From: [Yu, Olivia, EMNRD](#)
To: ["Robbie Runnels"; Jimenez, Yolanda](#)
Cc: [Jody Walters; John Farrell](#)
Subject: RE: [EXT] RE: Termination Request - Echo Production - Area 1 (1RP-4250)
Date: Friday, November 9, 2018 11:58:00 AM

Subject: Termination Request - Echo Production - Area 1 (1RP-4250)

1RP-4250

Soil Bore Location

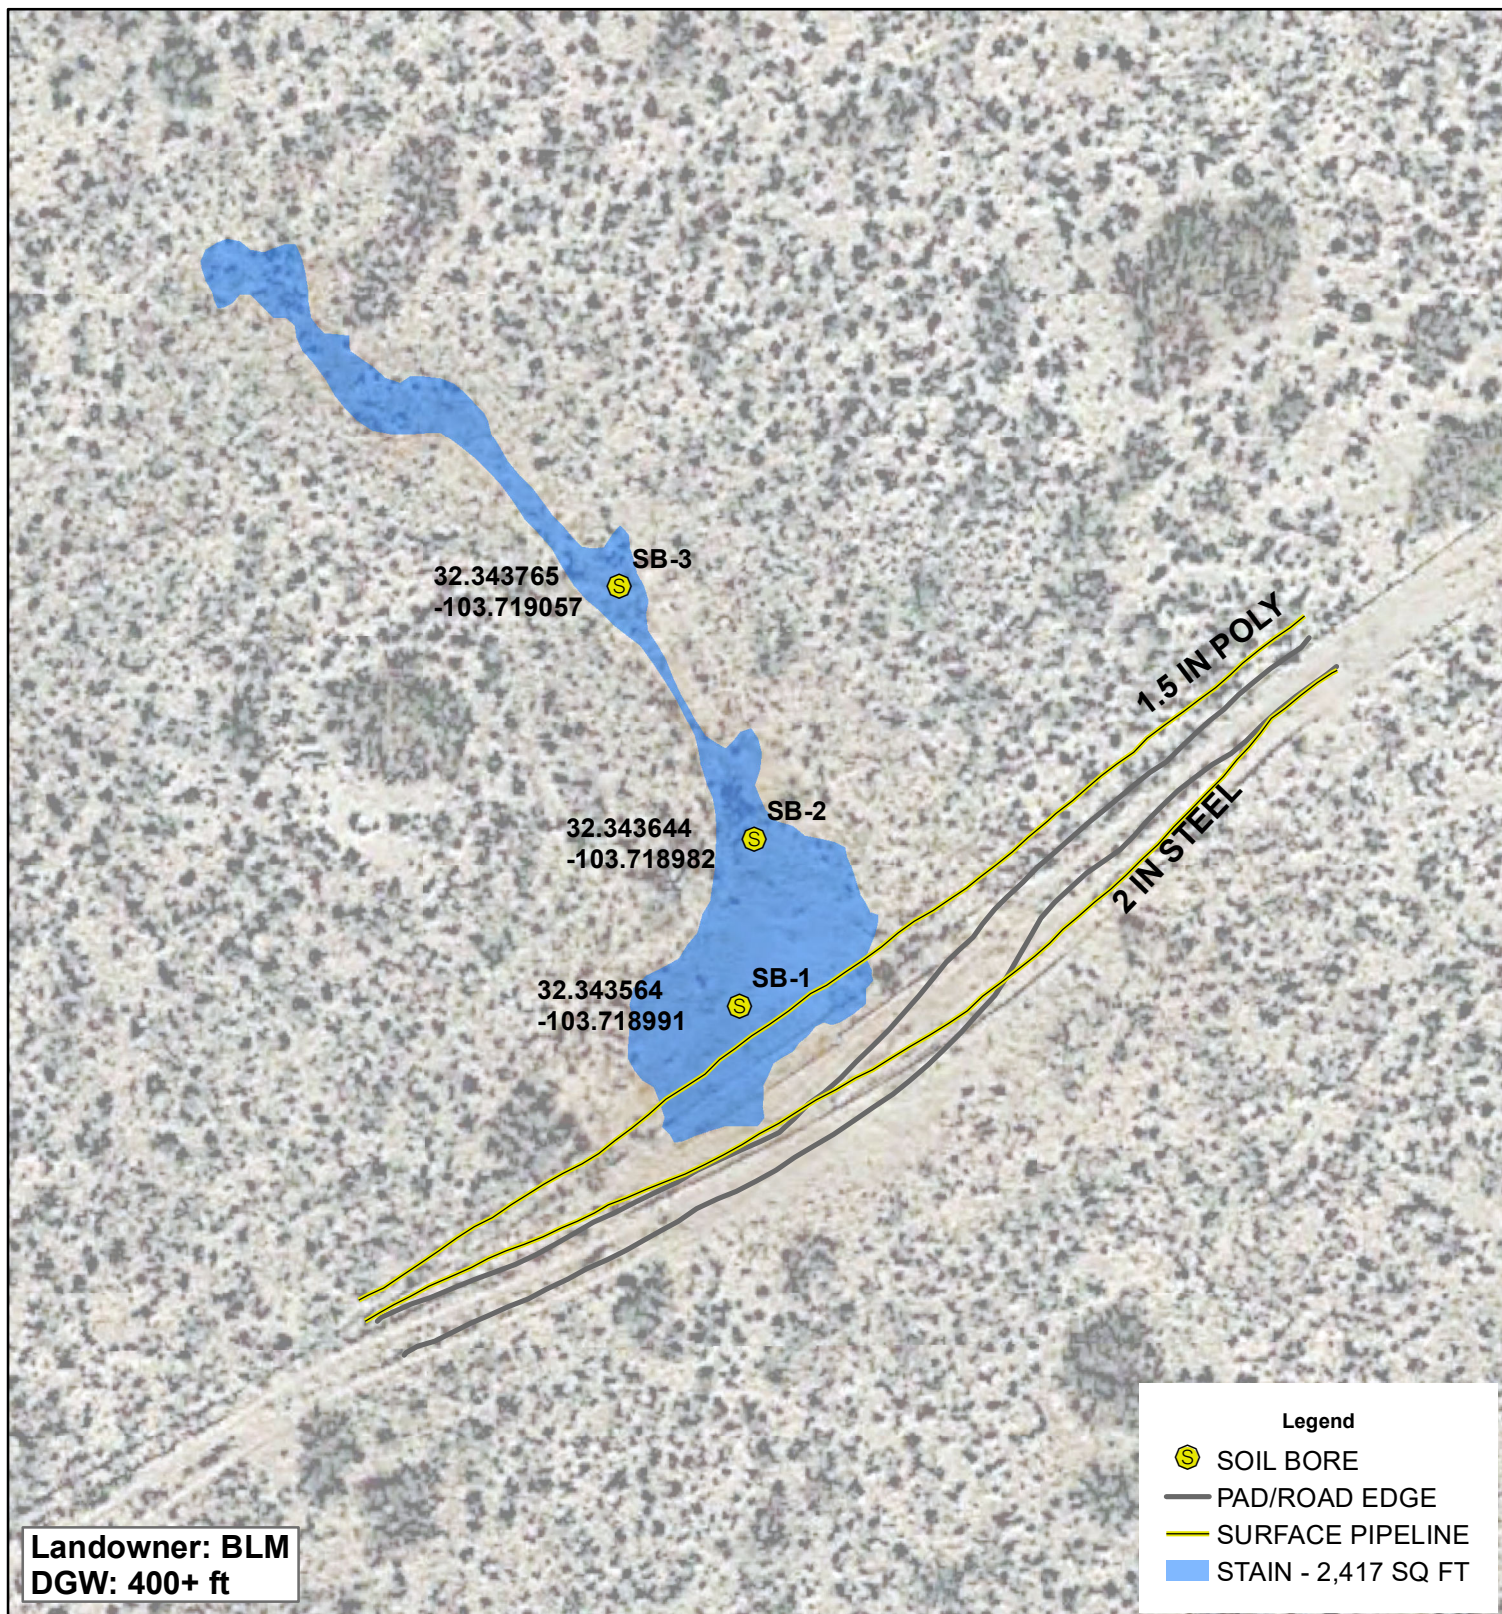
1. Is there field titration chloride data from depths above 90 ft. bgs for SB-1, above 110 ft. bgs for SB-2, and above 130 ft. bgs for SB-3? The chloride plume needs to be defined, not just the depth at which permissible chloride level was obtained.
2. Soil bore logs are incomplete. The same GPS coordinates were written for SB1 to SB-3.

Provide the actual locations of the soil bores. Where these soil bores over the same locations as Floor 1-3 locations, respectively?

Attached is the Soil Bore Map with coordinates. The driller used coordinates from the location. I have also attached our field notes. Please let me know if you need anything else.
